# UNITED STATES PATENT AND TRADEMARK OFFICE

APPLICATION NO.	FILING DATE	FIRST NAMED INVENTOR	ATTORNEY DOCKET NO.	CONFIRMATION NO.
10/712,265	11/14/2003	Nadine Ferdman Burton	051438-5002	8062
9629	7590	05/26/2005	EXAMINER	
MORGAN LEWIS & BOCKIUS LLP 1111 PENNSYLVANIA AVENUE NW WASHINGTON, DC 20004			HILL, LAURA C	
			ART UNIT	PAPER NUMBER
			3761

## Office Action Summary

## **DETAILED ACTION**

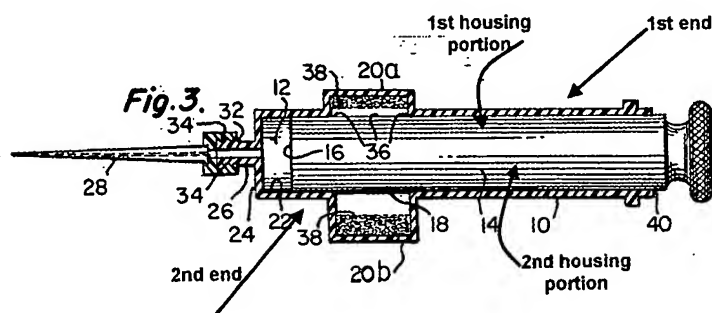
3. The 'first and second housing portions' of claim 1 are interpreted to include any surfaces on the valve, including or excluding inner and outer walls 216, 218, that define a cavity or unfilled space in the valve housing.
4. The 'actuator' of claim 1 is interpreted to be buttons 206 that collapse fluid passage of conduit 283 as recited in page 2 of the specification.

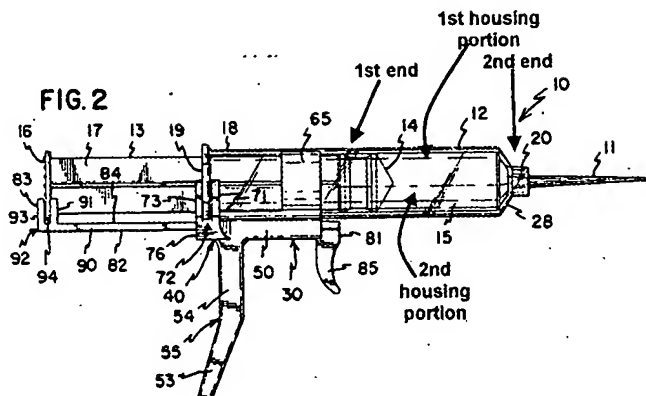
6. Claims 1-3 and 9 rejected under 35 U.S.C. 102(b) as being anticipated by Lee (US 5,115,816). Regarding claims 1-3 Lee discloses a disposable single-piece plastic aspirating device comprising an aspiration cylinder 10 and a syringe barrel/valve 12 (col. 3, ll. 19-21, col. 4, ll. 14-16), comprising:

A plunger /removable fluid conduit 13 having a first end for attaching to the aspiration cylinder 10 and a second end for attaching to needle/cannula 11 (figure 2);

A gasket/valve housing 14 having opposing surfaces/first and second housing portions (opposite interior and exterior surfaces) that define a cavity so interior plunger 13/removable fluid conduit is sealingly received within barrel/valve 12 (col. 4, ll. 32-38 and figure 2);

First and second housing portions capable of having a means for removably attaching since so interior plunger/fluid conduit 13 is removable;

A back wall/actuator 93, coupled to gasket/valve housing 14, that aspirates and directs fluid in a downward path into the barrel (col. 6, ll. 53-56 and figure 2).
